J&T Consulting, Inc.

April 8, 2024

RE: Bernhardt Sand and Gravel Pit, File No. M-2023-025,
112c Permit Application, Preliminary Adequacy Review

Exhibit C2 - Mining Plan Map

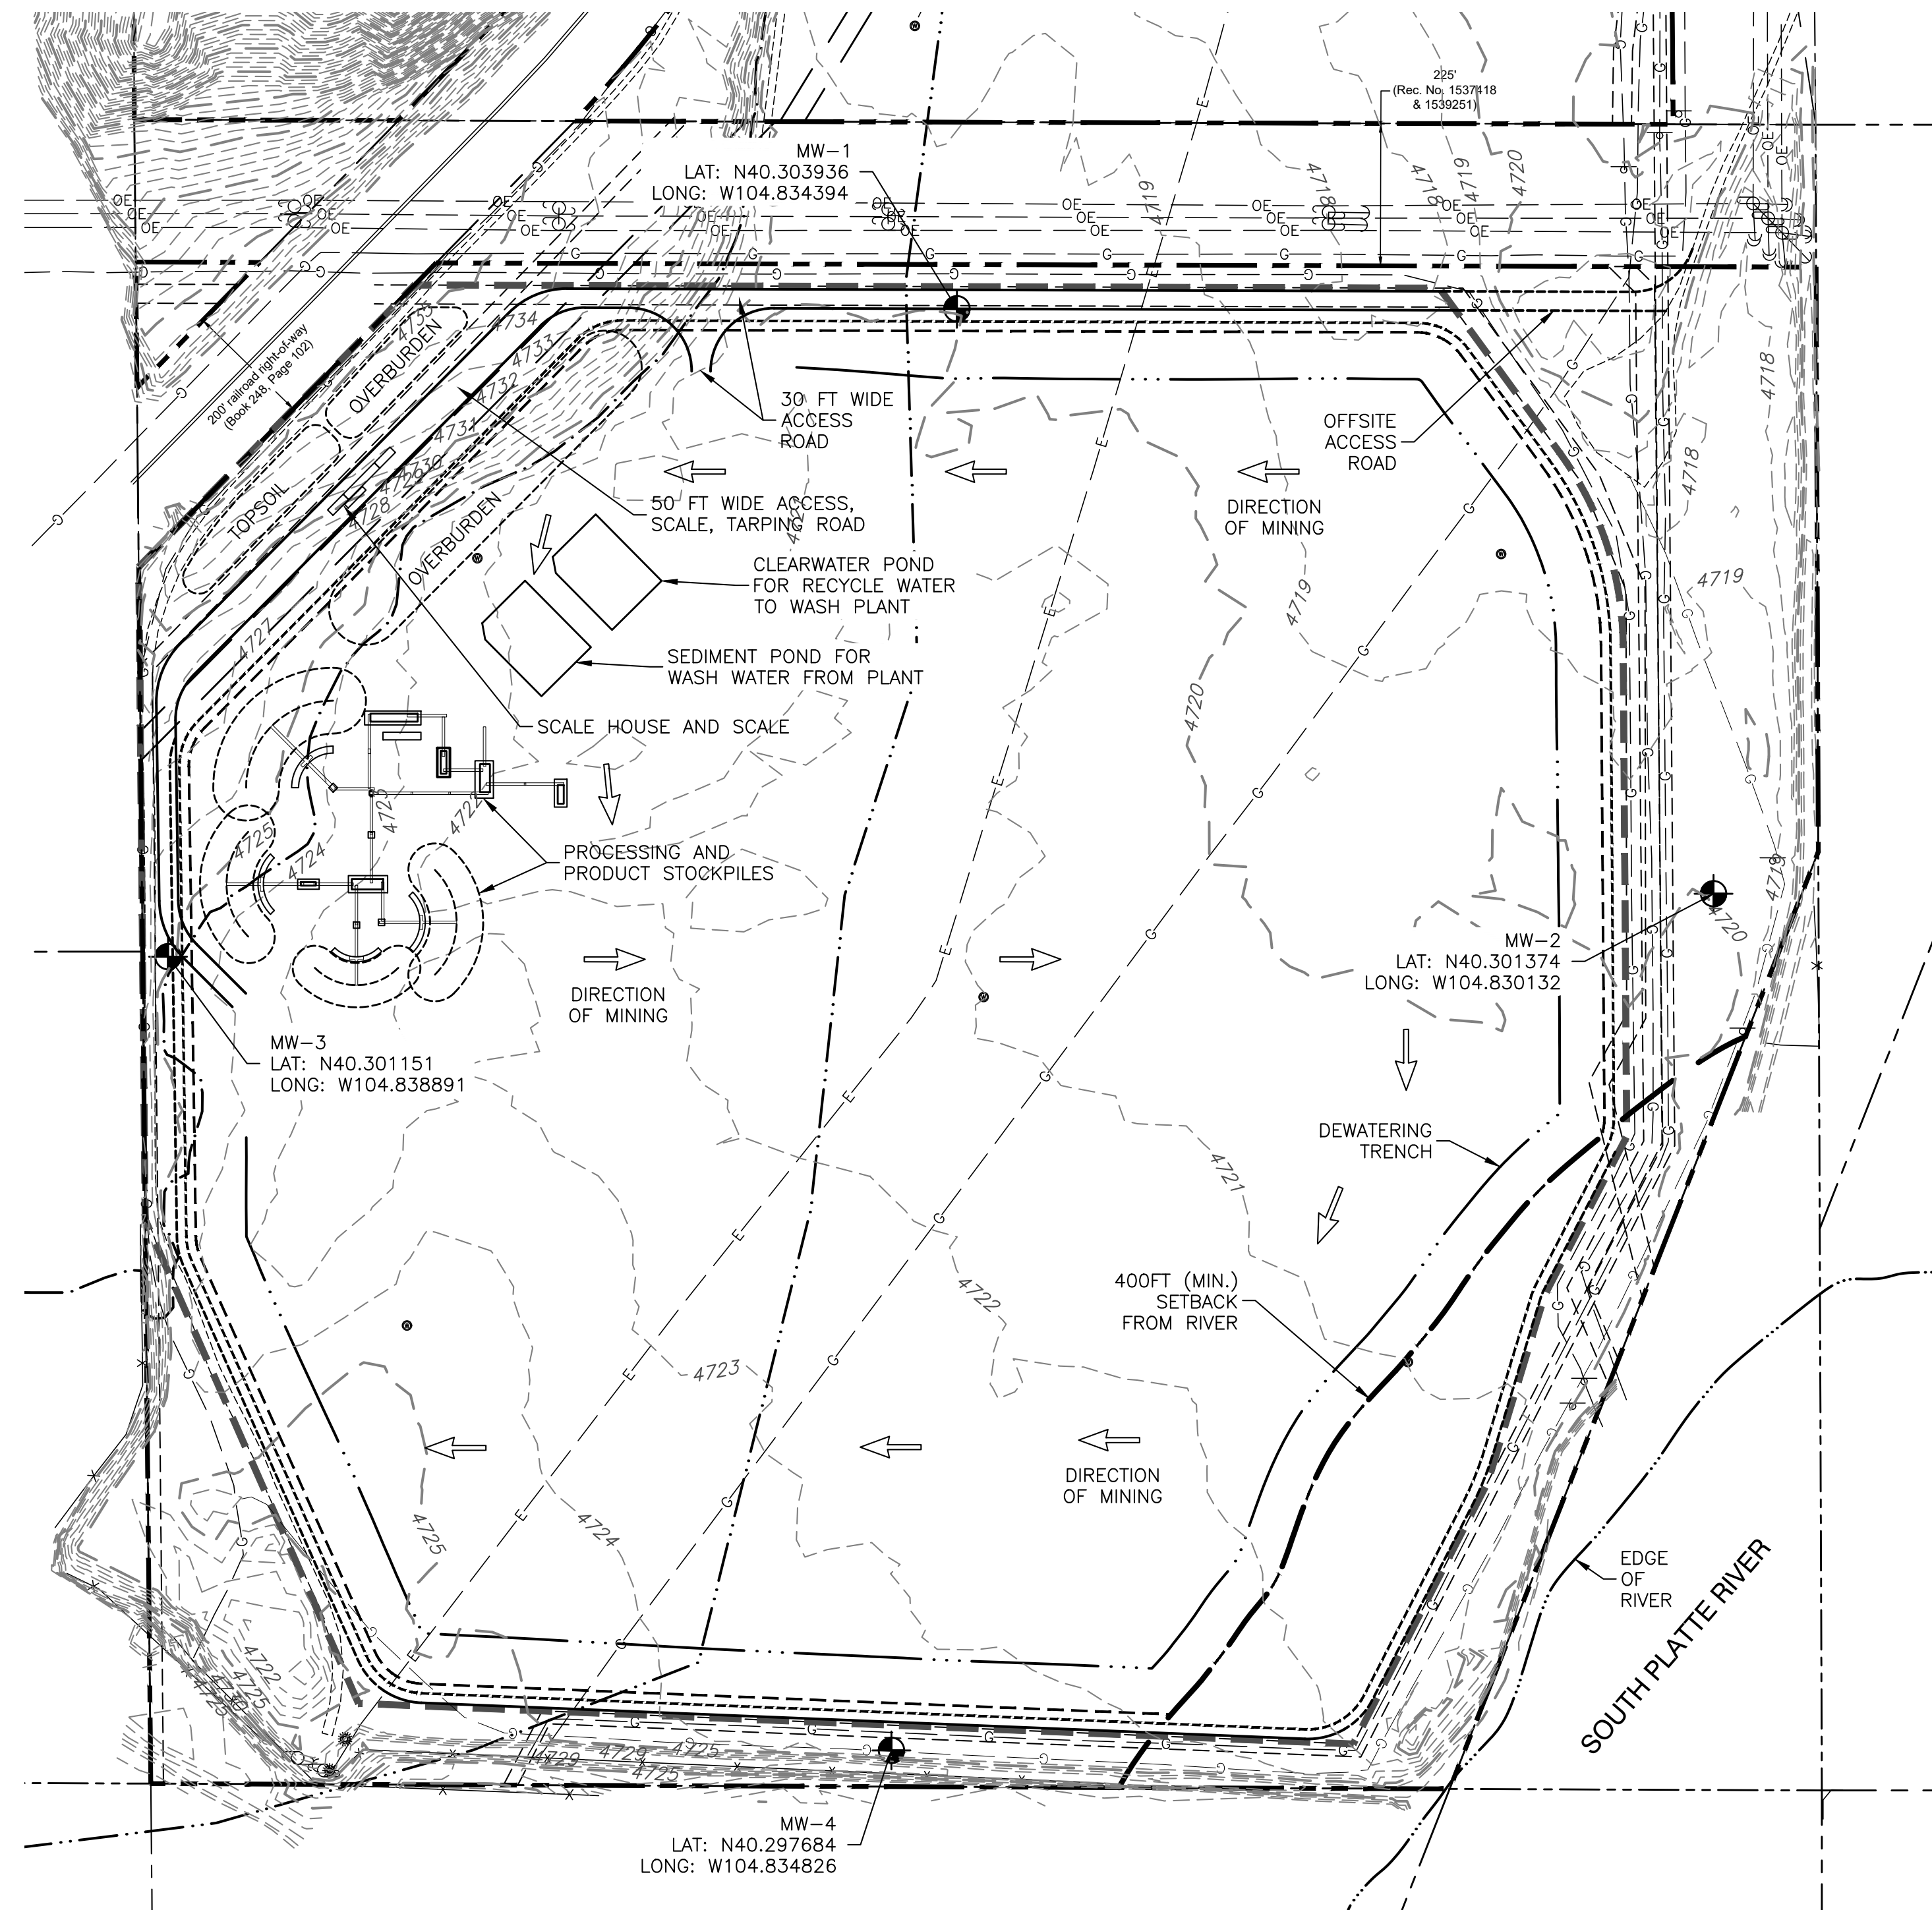
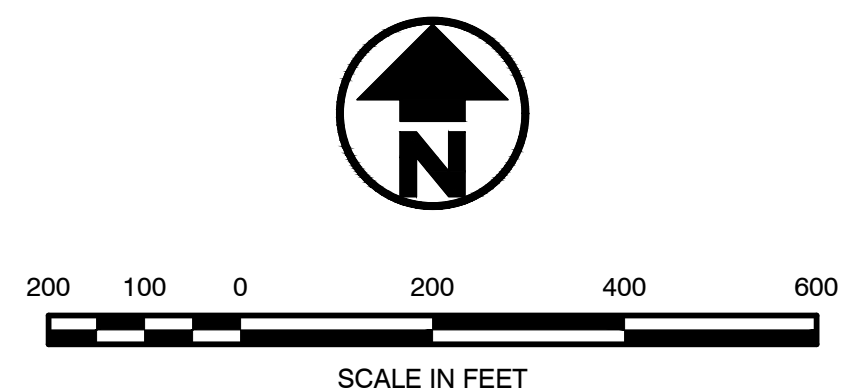
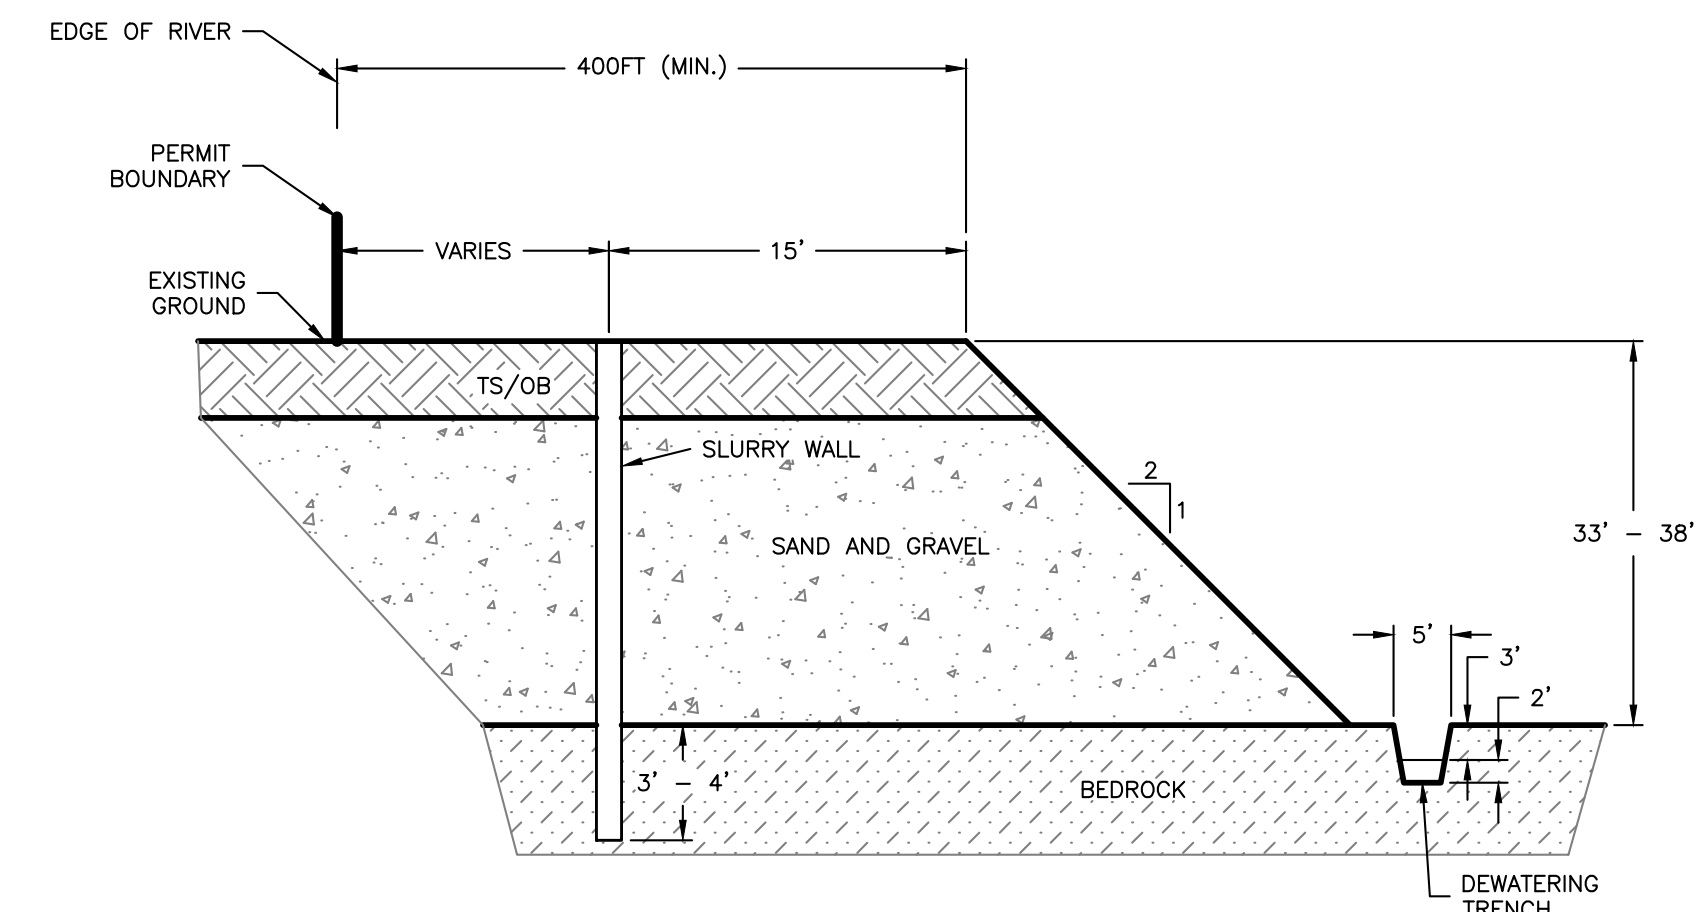
3) The South Platte River must be shown and labeled on maps C-1 and C-2, per Rule 6.4.3(b).

4) Please discuss if processing will entail washing of the product and if a pond or ponds will be included in the process area. If so, add a discussion to the text of Exhibit D and to Map C-2.

4) The Pre-Mining, Mining, and Reclamation Plan maps need to be updated to show the monitoring well locations associated with the proposed permit.

Response: Acknowledged. The maps C-1 and C-2 have been revised to show the South Platte River labels.

Response: Discussion has been added to the text of Exhibit D (See highlighted text in the attached updated mining plan) for the location of sediment ponds where the water is recaptured from washing product. The location is also shown on the revised map C-2.

Response: The Pre-Mining, Mining, and Reclamation Plan maps have been updated to show the monitoring well locations. (See attached updated maps)
